Our ref: 7200042  
Council ref: DA/24/2021

**RE: INFORMATION REQUEST & FUTURE ADVICE RESPONSE – LOT 1 & 5 HAMPTON DRIVE, BOYNE ISLAND QLD 4680 – LOT 1 RP619033 & LOT 5 RP620667**

Reference is made to the Information Request ('IR') and Further Advice ('FA') received on 23 July 2021 and 16 July 2021 from Gladstone Regional Council ('Council'). This letter has been prepared by Ethos Urban on behalf of the Applicant, ZenDev, to provide a combined response to the IR and FA in accordance with section 13.2(a) of the *Development Assessment Rules*. For ease of reference, the following letter uses the same numbering as the IR and FA and the relevant items are shown in blue boxes.

**Figure 4. Aquatic center view and accessibility analysis**

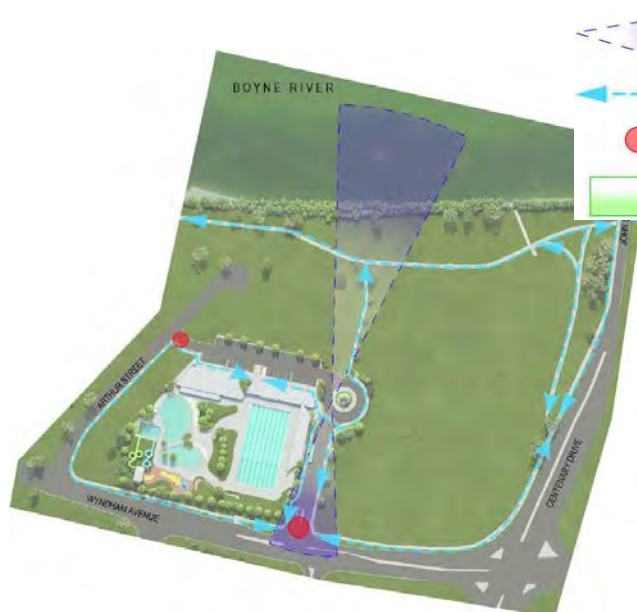
**Response to Item 2:**

**Figure 4** provides a view and access analysis of the proposed Stage 1 Aquatic Centre development. **Figure 5** provides a similar analysis of the concept masterplan, which also identifies access through, along and around the site, the presence of view corridors through the site and along the river, and the activation of the river edge. Where the proposed Aquatic Centre is approved and future stages of the masterplan proceed, elements within the ‘Precinct 2 – River Activation Precinct’ that include additional green space, community club, dining and entertainment along the Turtle Way Bikeway will reinforce, promote and activate the river edge to create a vibrant community focal point.
